## Transport Assessment

Moorebank Intermodal Precinct West – Stage 3 (SSD 10431)  
(Response to Submissions)

Ref: P1277r02v1  
28/07/2020

**Figure 5: Network Traffic Volumes, with MPW S2 - Scenario 2**

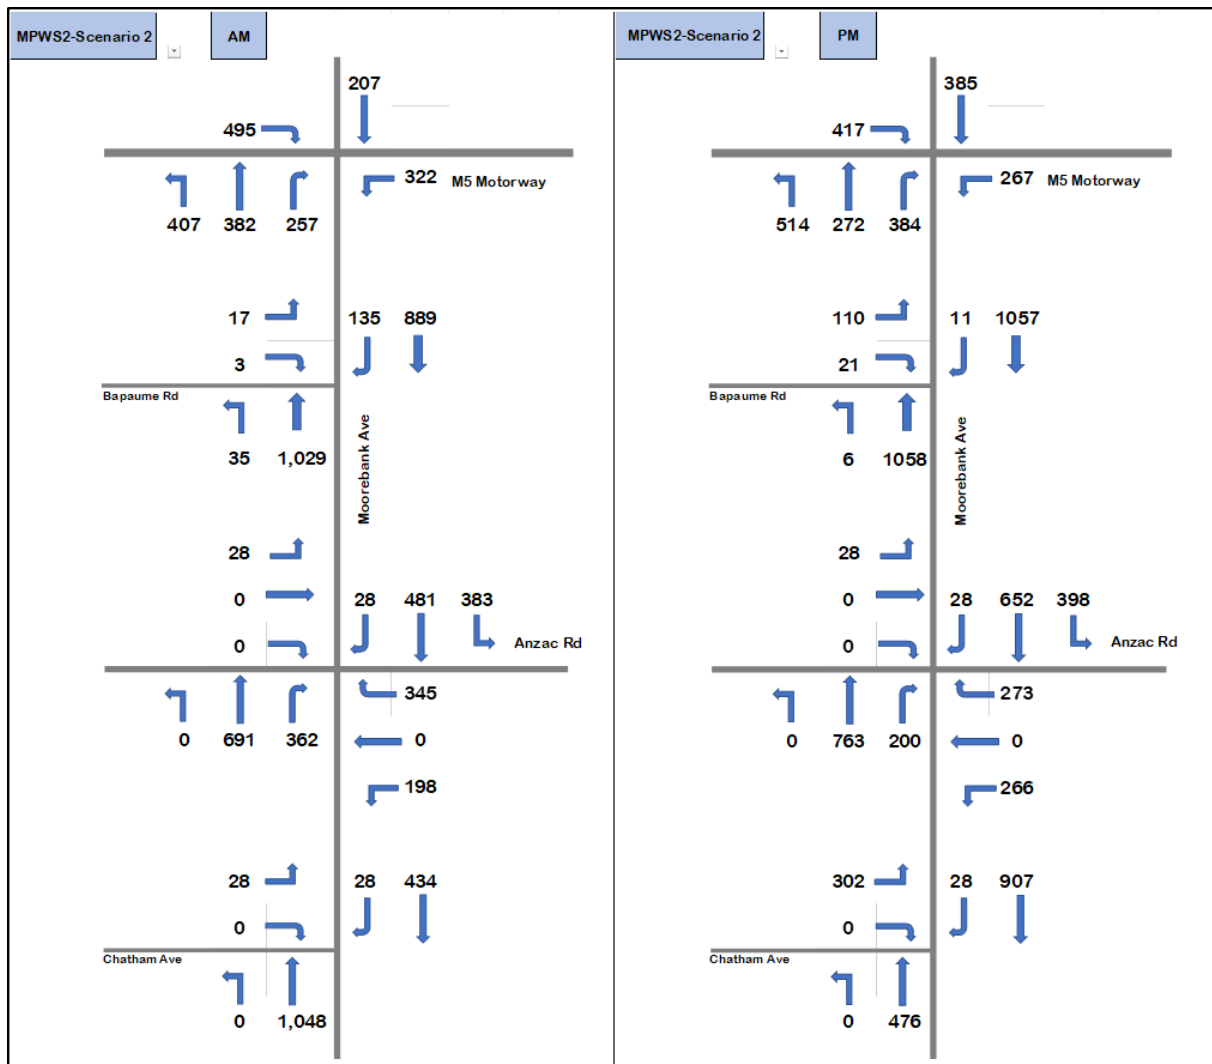
TfNSW Comments	Ason Group Response
<p><b>Network Traffic Volumes, with MPW S2 - Scenario 2</b></p> <p><u>Comment</u></p> <p>It is noted that Figure 5 of the Transport Assessment prepared to support the development application states that the traffic volumes included in Figure 5 are based on the Moorebank Precinct West (MPW) Stage 2 Proposal - Construction Traffic Impact Assessment, dated October 2016 (2016 MPW Report).</p> <p>It advised that:</p> <ul style="list-style-type: none"> <li>Based on the traffic distribution adopted for Stage 2-Scenario 2 in Figure 5 of the Transport Assessment, number of construction vehicle movements included in Figure 5 are lower during the morning peak period and higher during the afternoon peak period compared to the construction traffic movements reported in the 2016 MPW Report; and</li> <li>Morning and afternoon traffic movements for Stage 2-Scenario 2 included in Figure 5 are not the same as traffic movements included in 2016 MPW Report for this scenario.</li> </ul> <p><u>Recommendation</u></p> <p>It is requested that the applicant clarifies the apparent inconsistencies between the Transport Assessment Report and the Moorebank Precinct West (MPW) Stage 2 Proposal - Construction Traffic Impact Assessment, dated October 2016</p>	<p>TfNSW (and other submissions) are referencing an earlier 2016 CTIA report, whereas the submitted report relies on the later 2017 Response to Submissions CTIA report volumes—see below.</p> <div data-bbox="900 777 1358 1417" data-label="Image"> </div> <p>For clarity, the figures adopted came from Figure A-5 and A-6 of that report by Arcadis.</p>
